RE: Lincoln Drive Median Access from Mockingbird Lane to the Eastern Town Limits

MEMORANDUM

Subject: Lincoln Drive, Mockingbird Lane to Town of Paradise Valley (TOPV) Jurisdiction
Median Breaks and Access
Third Party Traffic Review Comments

Figure 4.2 Process for Selecting Average Rate or Equation
in Trip Generation Manual Data

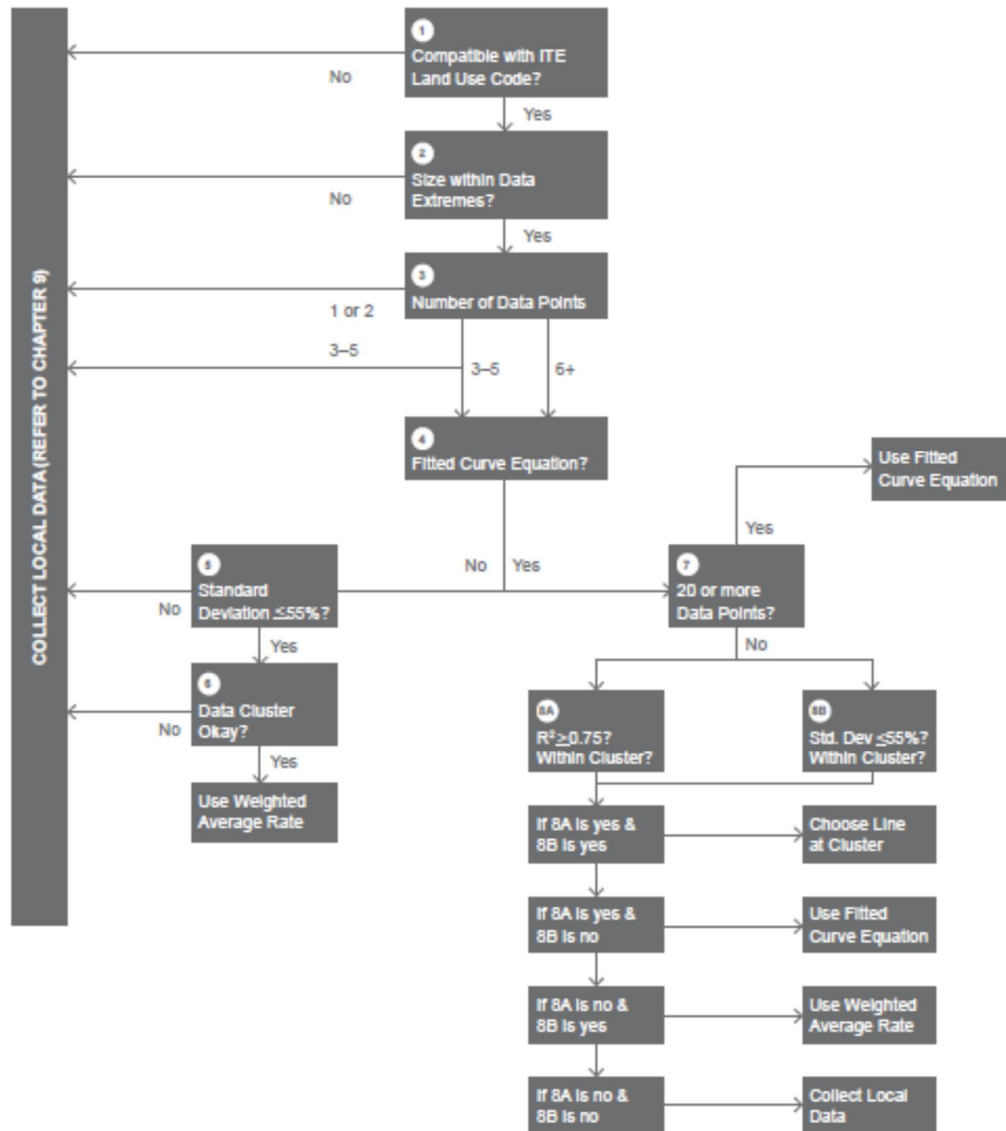
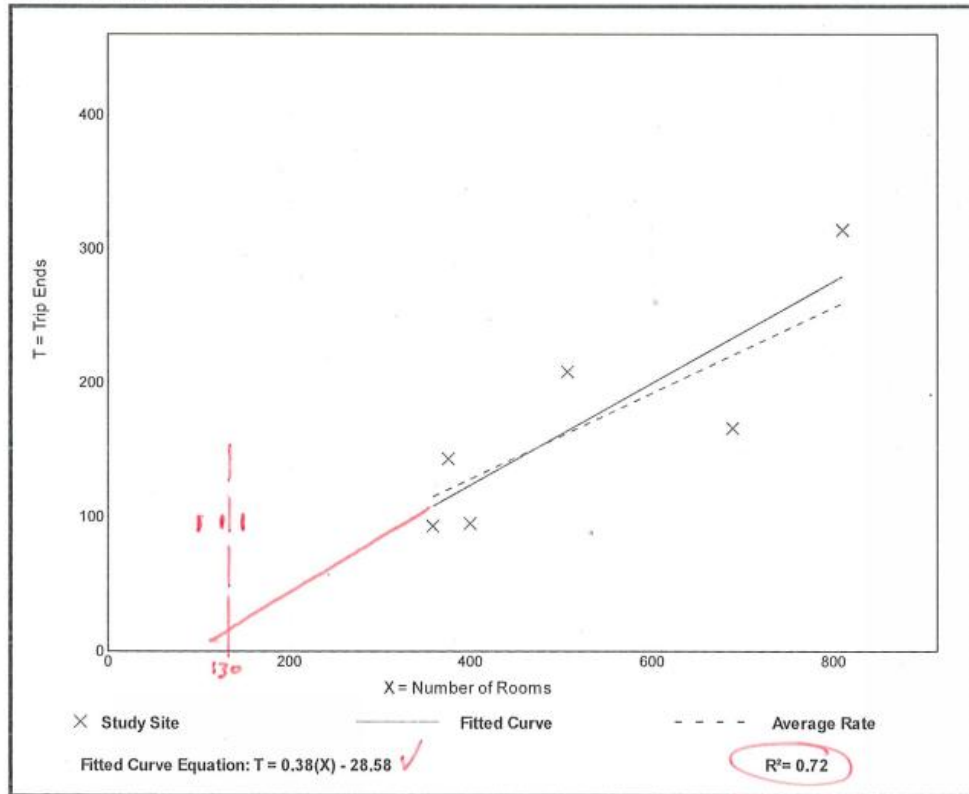
KH Comments 4: Smoke Tree Resort utilized equations as opposed to average rates. KHA went through the ITE Trip Generation Handbook process presented in Figure 4.2 assuming proposed number of units for resort hotel (LUC 330). The results of this process are presented below and KH redlines provided in **Appendix 1**.

- The number of rooms is way out of range of the data extremes; the lowest number of rooms in the manual is roughly 370 compared to the 132 that are proposed
- If you follow the equation, which happens to be a straight line and not a logarithmic function, then 132 rooms will generate a very low number of trips
- The number of data points is equal to 6
- The R2 value is close to the required 0.75, so you could argue it either way
- The standard deviation is less than 55% of the average rate

Because the rooms are not within the data extremes and the R2 value is less than 0.75, we recommend the weighted rates be used. Using the rates as opposed to the equation results in double the trips being generated in the AM peak hour.

Response to Comment 4: CivTech has updated the trip generation rates to reflect a blended rate between LUC 310 and 330 as discussed in response to comment #3. The trip generation calculations were also revised to reflect 150 rooms, 30 residential units, and 3500 square foot quality restaurant. The revised trip generation calculations and approach were considered acceptable. The revised trip generation calculations, based on 150 rooms, 30 residential units, and 3500 square foot quality restaurant, are provided in **Appendix 2**.

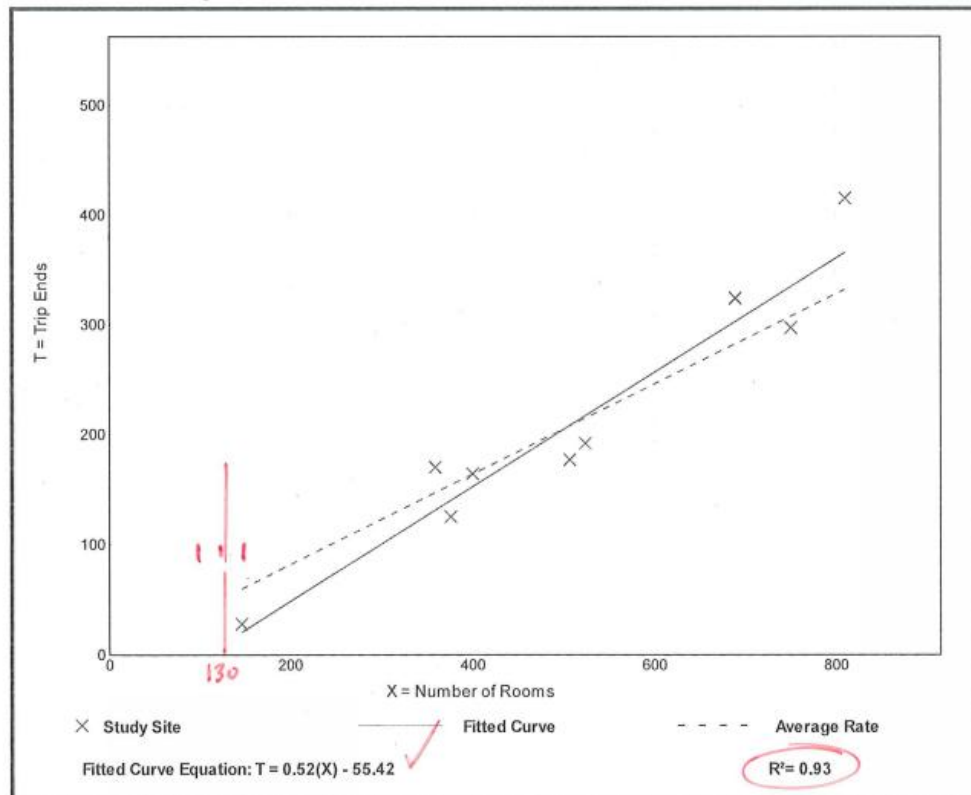
Resort hotel PM peak hour between 4-6pm

- The number of rooms is just outside of the data extremes
- The number of data points is greater than 6
- The R2 value is well above the required 0.75
- The standard deviation is less than 55% of the average rate

Because the number of data points and the R2 value are high enough and the standard deviation requirement is met, the use of the equation during the PM peak is appropriate.
